COMMUNICATION 132100

Received From: Niki Dwyer, MCIP RPP, Director of Development Services
Addressed To: Committee of the Whole
Date: August 10, 2021
Topic: Taber Street – Block 4 Townhome Proposal (DP3-01-21)

Figure 5 – Garage Floorplan

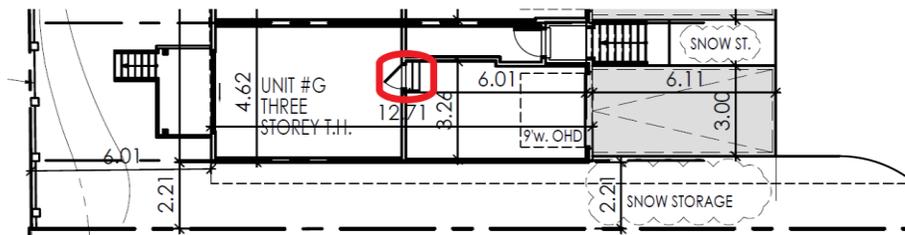
In reviewing the final submitted floor plan package, staff noted the addition of a set of stairs in the garage which may obstruct the clearance length for the vehicle. It is possible that at time of building permit review the final elevations for the entrance will require an encroachment and will result in the requirement for cash-in-lieu of parking for one (1) of the spaces to compensate for the loss of sufficient parking.
